MOTOROLA UK
 REDWOOD
 CROCKFORD LANE
 CHINEHAM BUSINESS PARK
 CHINEHAM
 BASINGSTOKE
 UNITED KINGDOM RG24 8WQ
 CSB-1168-2
 Country : UK
 Date : 11/2/2007
 APC : D54
 Repair Level : 2

Title V3V3 05 CR - GSM - Main Display Crack Driver IC
 Model Affected V3 & V3_05

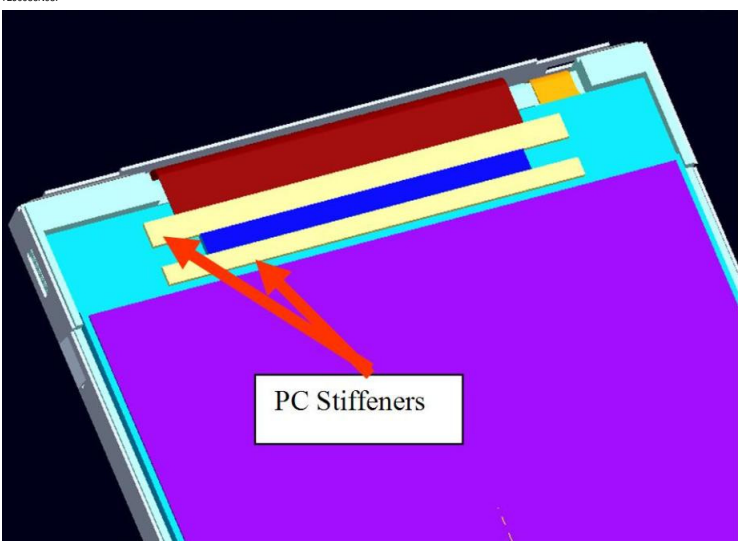
Service has been made aware of a V3 & V3_05 Main Display Crack Driver IC issue causing "Display Main - No display & Display Main - Missing Pixels / Icons" complaints.

The cause of the crack driver IC was determined to be physical force being applied at the Main lens by the Motorola Logo. Sharp displays are more susceptible to this issue due to its mechanical characteristics.

PC Stiffeners were added at around IC to increase rigidity on Sharp displays. The part numbers change from 7290086N02 to 7290086N08.
